25-Mar-2025 - Redlines - DD

Duncans Creek - Lot 27

NEW HOME
INC.

The Brunswick French Country - RH

FIRST FLOOR PLAN - FRENCH COUNTRY

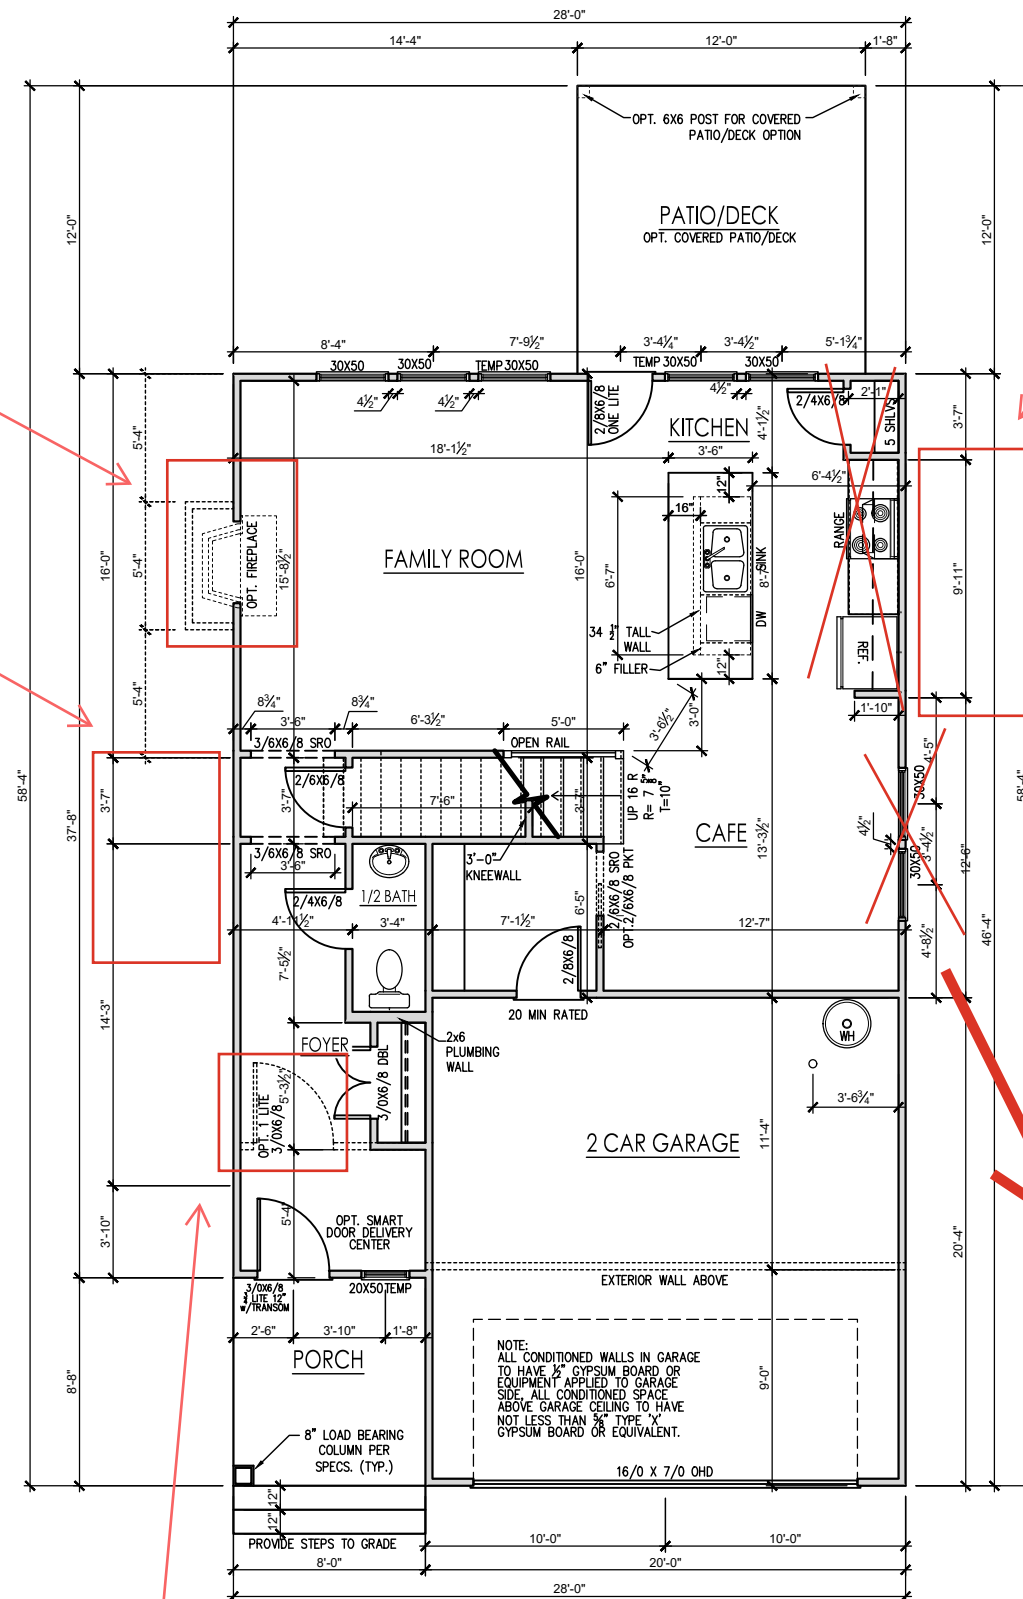
Messy Kitchen/ Power Pantry - Kitchen Layout Changes

Sink/Window @ Messy Kitchen

Pocket Office Front
Elevation - See Left

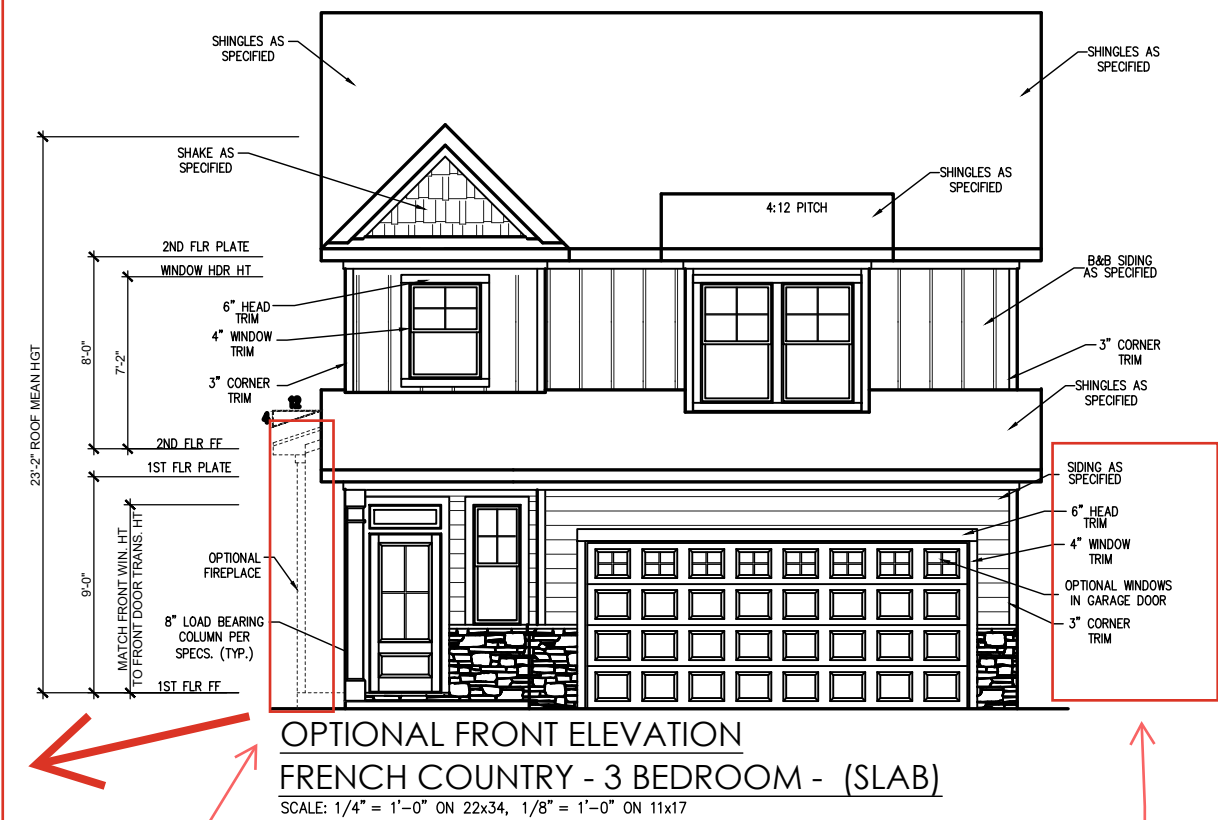
Messy Kitchen/
Power Pantry Front
Elevation - See Right

REAR ELEVATION (SLAB)
SCALE: 1/4" = 1'-0" ON 22x34, 1/8" = 1'-0" ON 11x17

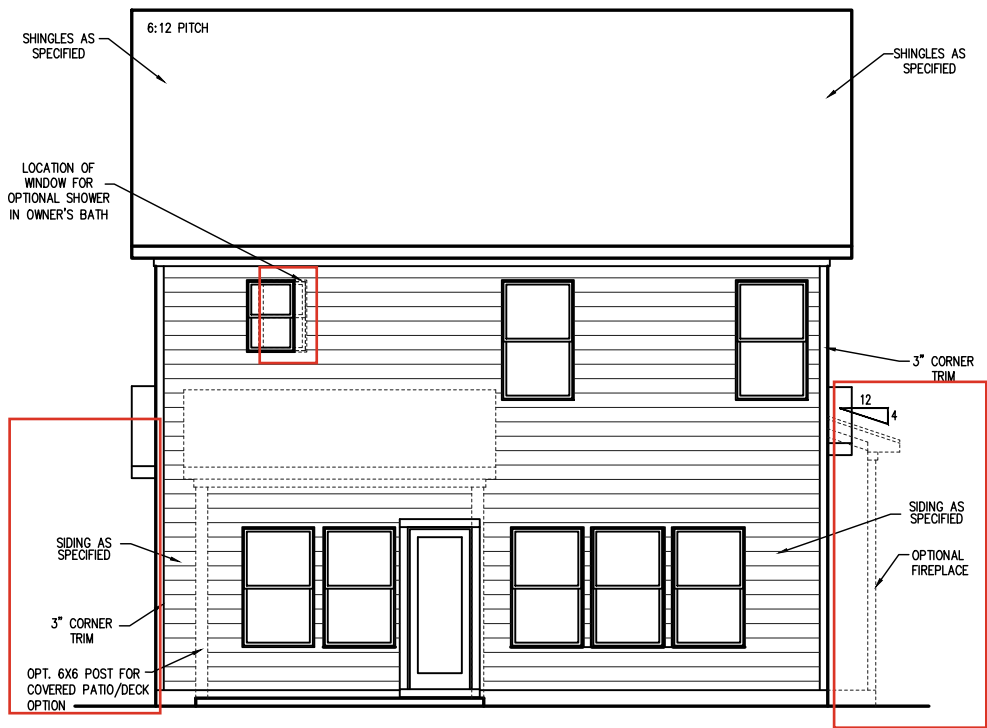
Messy Kitchen/
Power Pantry Rear
Elevation - 3.2

RIGHT ELEVATION (SLAB)
SCALE: 1/4" = 1'-0" ON 22x34, 1/8" = 1'-0" ON 11x17

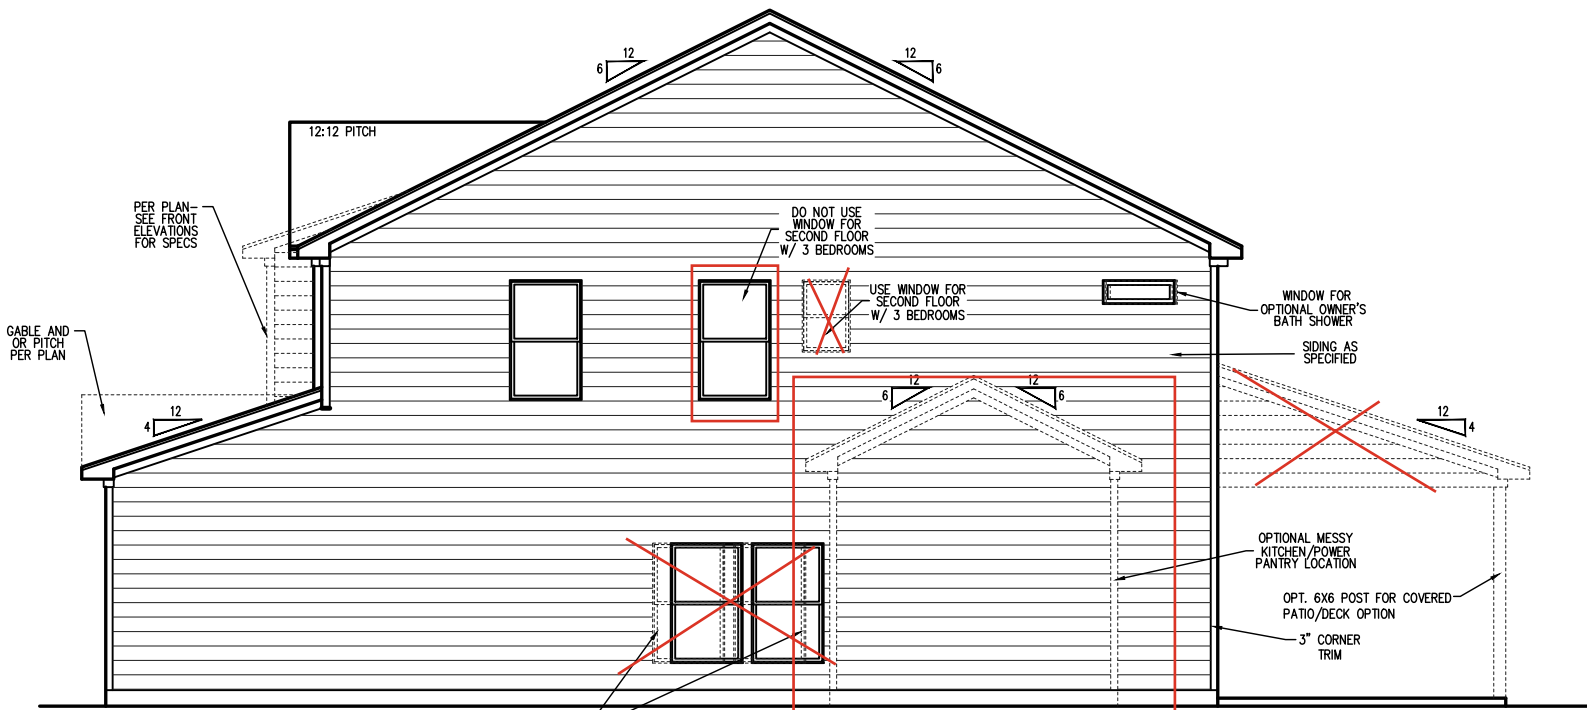
Pocket Office Rear
Elevation - 3.2

Opt. Cafe Window
Locations - 3.2

LEFT ELEVATION - FRENCH COUNTRY (SLAB)
SCALE: 1/4" = 1'-0" ON 22x34, 1/8" = 1'-0" ON 11x17

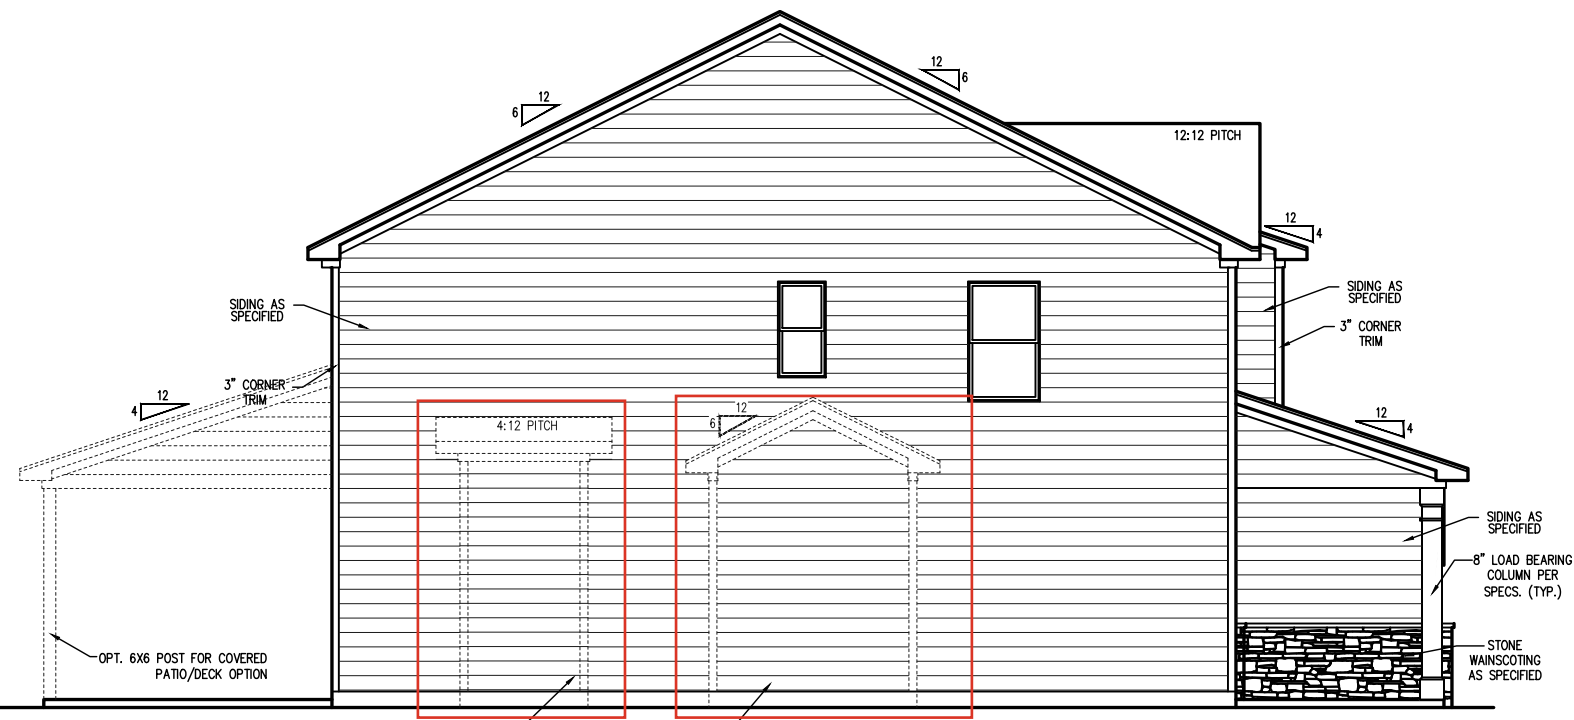
Messy Kitchen/
Power Pantry

Pocket Office and
Fireplace

OPTIONAL
FIREPLACE

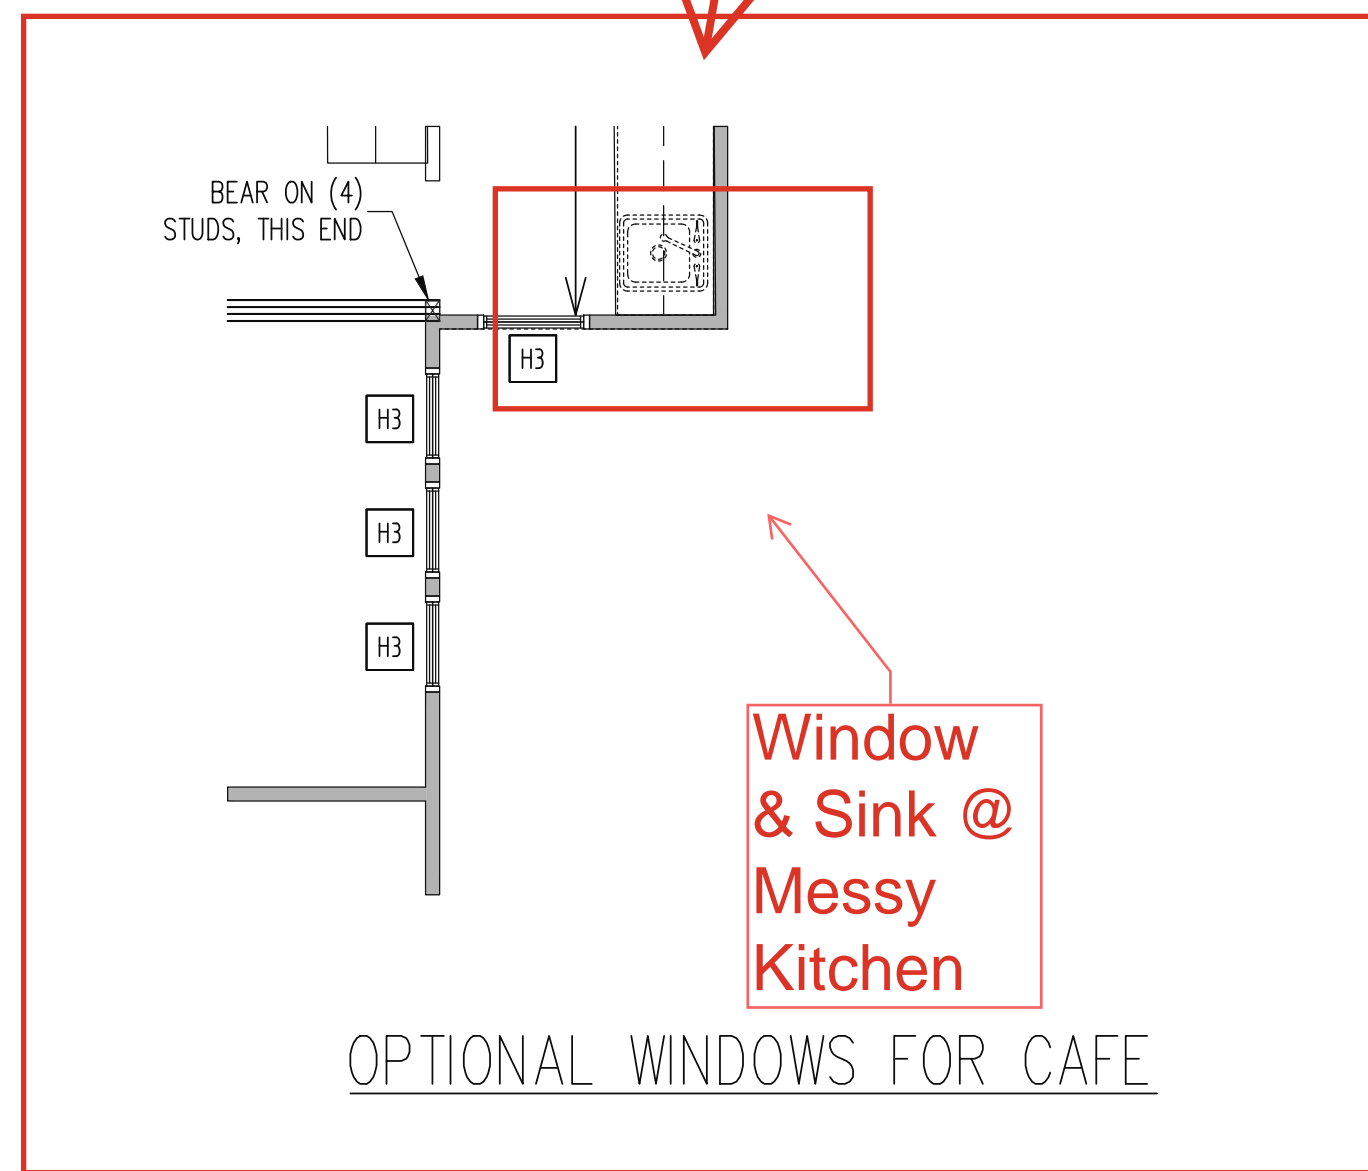
Window
& Sink @
Messy
Kitchen

Messy Kitchen/Power
Pantry - Kitchen
Layout Changes -
See Left

Pocket
Office -
See
Right

Smart
Door
Delivery

Opt. Cafe
Windows
- See Left
